SUBJECT: TASK INTERFACE AGREEMENT (TIA) – OPERABILITY OF THE NUCLEAR SERVICE COOLING WATER SYSTEM – VOGTLE ELECTRIC GENERATING PLANT (TIA 2009-008)

This Task Interface Agreement (TIA) documents the applicable regulatory position determined by the Office of Nuclear Reactor Regulation (NRR) and Region II regarding Vogtle Unit 1 and Unit 2 Nuclear Service Cooling Water (NSCW) system operability per Technical Specification (TS) 3.7.8 with the NSCW tower return valves in manual control. This TIA is associated with Unresolved Item (URI) item 05000424, 05000425/2008009-01.

NSCW TRAIN A

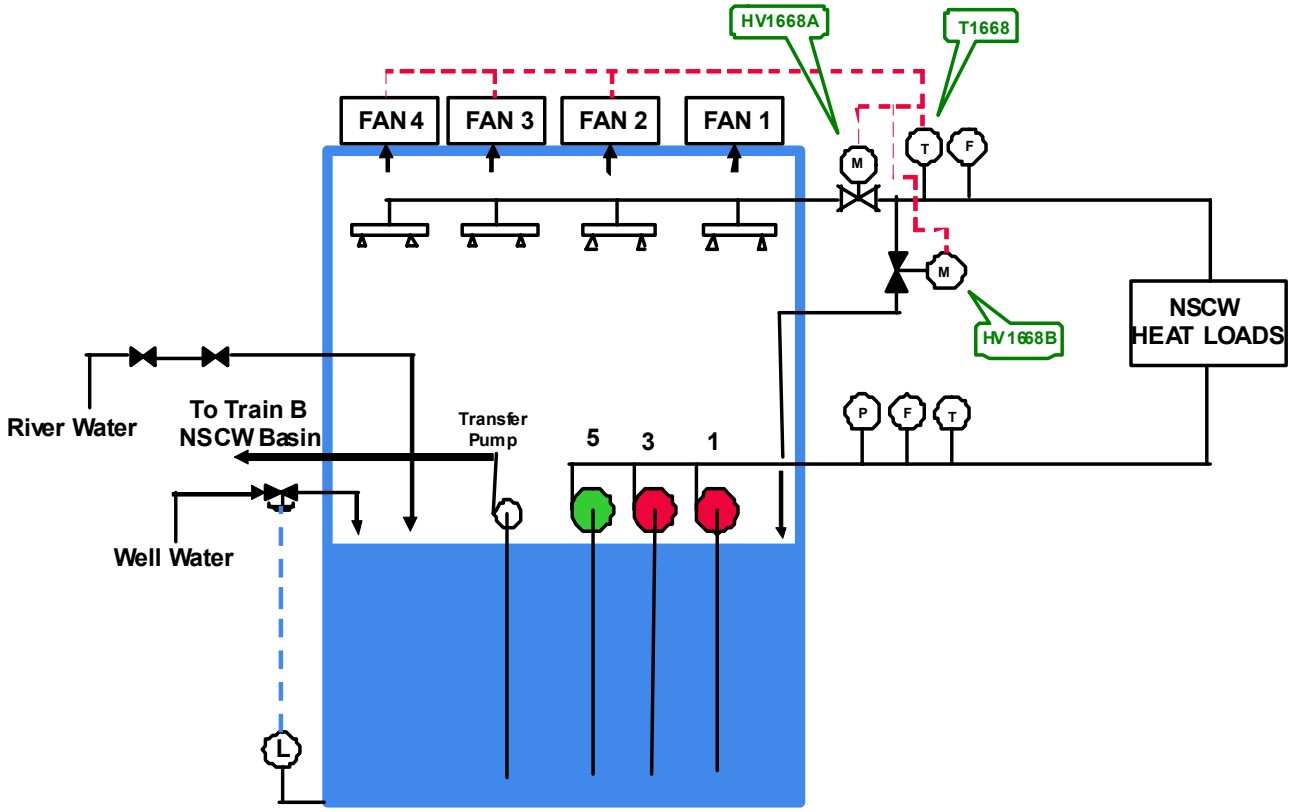
The tower return valves are operated in the OPEN BYPASS for routine surveillances and during maintenance for personnel protection approximately once per quarter per train. Placing the tower return header control switch in OPEN BYPASS disables the automatic spray cooling function, which is required to maintain the NSCW system within its design limits following a loss-of-coolant accident. With the automatic design function disabled, the NSCW system no longer meets the TS definition of OPERABLE. Therefore, the NSCW system should be declared INOPERABLE when the tower return header control switch is placed in the OPEN BYPASS position and entry into TS LCO 3.7.8 Condition A is required. This is true whether the temperature element TE1668 is out of service for calibration or not. Having temperature element TE1668 out of service for calibration makes step 5 in the emergency operating procedure E-0 ineffective in restoring flow to the spray header and disables the one control room alarm that could alert operators to a problem with NSCW.

The Vogtle Updated Final Safety Analysis Report (UFSAR) Section 9.2.1.1.1.G "Safety System Design Bases" states that "the NSCW system is designed to perform its cooling function following a loss-of-coolant accident (LOCA), automatically and without operator action, assuming a single failure coincident with a loss of offsite power." When the tower return header control switch is in OPEN BYPASS, the automatic opening feature of the return valve is disabled and the bypass valve will remain open regardless of the NSCW return water temperature, which prevents proper cooling of the NSCW system without operator manual action. With no cooling capability for the water returned to the NSCW cooling tower, the ultimate heat sink cannot be relied upon to supply water at the proper temperature to the NSCW system for much more than 30 minutes under UFSAR worst case conditions. During this initial time period of a design basis LOCA, the operator cannot be relied upon to remember that the temperature element is out of service and initiate manual actions to provide spray cooling. This condition presents a single-failure vulnerability for the other train of NSCW.

The licensee's contention, that the correct position for the tower return valves as they relate to SR 3.7.8.1 is relative, is incorrect. In accordance with 10 CFR 50.36(b), the "technical specifications will be derived from the analyses and evaluation included in the safety analysis report, and amendments thereto, submitted pursuant to 10 CFR 50.34." The correct position for these valves is ready for automatic operation without operator action as assumed in the LOCA analysis.

Modifying the position of the tower return valves from the position required by SR 3.7.8.1 results in a failure to meet that SR. As required by TS SR 3.0.1, this is a failure to meet TS LCO 3.7.8 and the associated NSCW train should be declared inoperable. In accordance with TS LCO 3.0.2, entry into TS LCO 3.7.8 Condition A is required. These TS requirements must be met regardless of the operability status of temperature element TE1668.
